**BOARD OF ZONING ADJUSTMENT  
STAFF REPORT****Date: June 5, 2017****CASE NUMBER**

6116

Betty Bush, for The Bush Tot Spot

**LOCATION**1610 Union Street  
(East side of Union Street, 657'± South of Rochester Street)**VARIANCE REQUEST****USE:** Use Variance to allow a daycare in an R-1, Single-Family Residential District.**BULK/SITE:** Bulk/Site Variance to allow multiple buildings on a single-site for a commercial daycare in an R-1, Single-Family Residential District.**TREE PLANTING:** Tree Planting Variance to allow reduced frontage tree plantings for a commercial daycare in an R-1, Single-Family Residential District.**PARKING RATIO:** Parking Ratio Variance to allow six parking spaces for a commercial daycare with seven teaching stations in an R-1, Single-Family Residential District.**SURFACING:** Surfacing Variance to allow gravel surfacing for a commercial daycare in an R-1, Single-Family Residential District.**ACCESS AND MANEUVERING:** Access and Maneuvering Variance to allow a 21.5' + driveway for two-way traffic for a commercial daycare in an R-1, Single-Family Residential District.**ZONING ORDINANCE

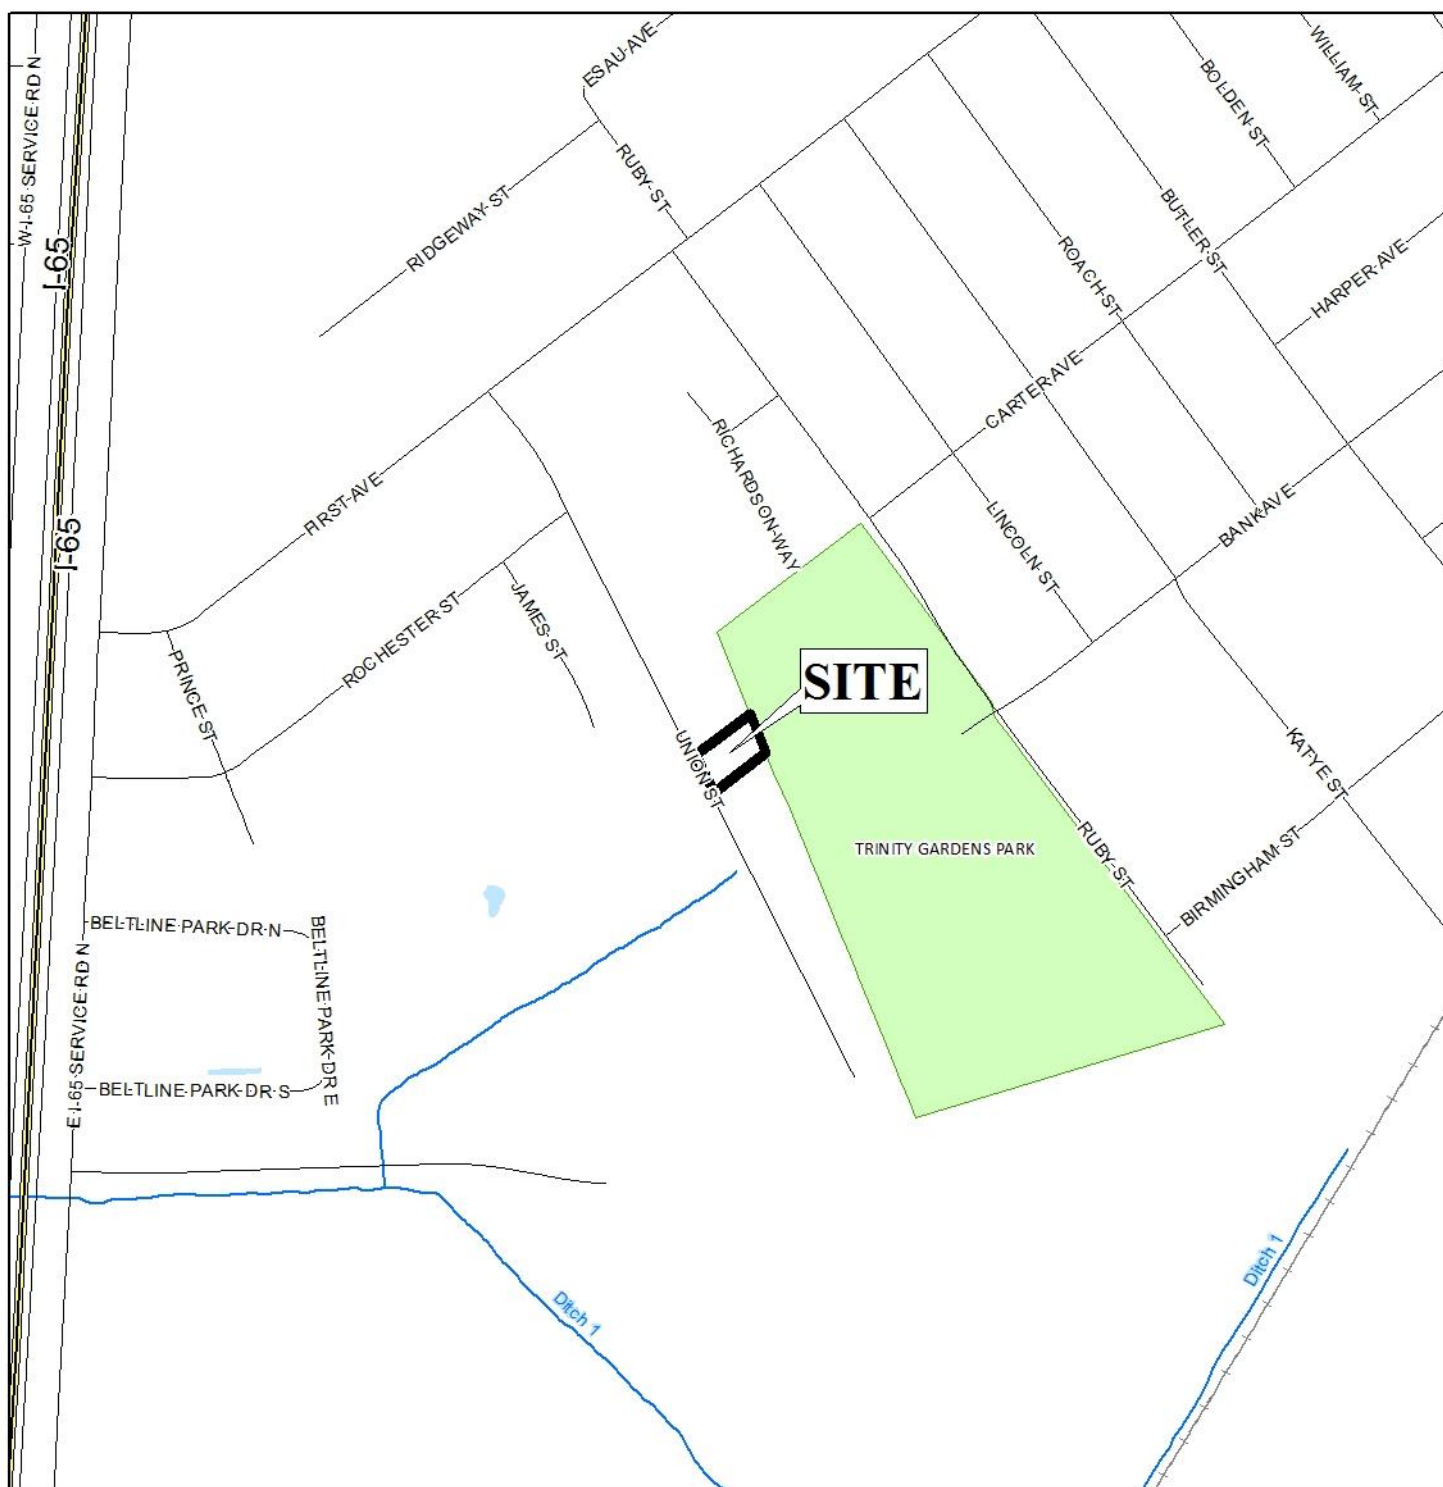
If the aggregate surfacing is approved for use the applicant will need to have the following conditions met:

- a. Submit and receive a Land Disturbance Permit for the proposed site development through Central Permitting. The handicapped parking spaces and must be paved. Aggregate surfacing will NOT be allowed within the public ROW.
- b. Submit a ROW Permit (City of Mobile Eng. Dept.) for the work within the Public ROW. Aggregate surfacing will NOT be allowed within the public ROW.

If the surface variance is approved, bumper stops should be included on the gravel surface to delineate any required parking spaces (illustrated on site plan). Aggregate cannot extend into the right-of-way and cannot be used in the areas designated as the accessible path from the required handicap space to the building. Consult with Engineering and Traffic Engineering for the design of the concrete apron. Because the right-of-way for Union Street is narrow, additional apron width may be require onto the site to further prevent any gravel from entering the roadway. The proposed 5' radii are also appropriate given the narrow width of the street; they are more in line with a residential standard.

As for the access and maneuvering variance, it appears that there is sufficient area on the site to adjust the parking to provide the needed additional 3 to 4 feet to widen the drive to the required minimum width.

Aggregate surfacing of the parking and maneuvering area, with the exception of the accessible parking space, would reduce storm water runoff, but might also cause challenges for parents pushing children in strollers. Also, since the site is within AE and X-shaded flood zones, aggregate surfacing may not be suitable due to poor soil conditions.

With only six proposed parking spaces, and a capacity of 30-40 proposed children ages two to four years, plus infants, there is a concern of insufficient available parking for parents dropping off or picking up their children, as well as for employees. While the pick-up and drop-off activities may be spread throughout the day, if there is insufficient parking on the property,

parents may be forced to park partially in the roadway, further exacerbating access for emergency vehicles and other residents.
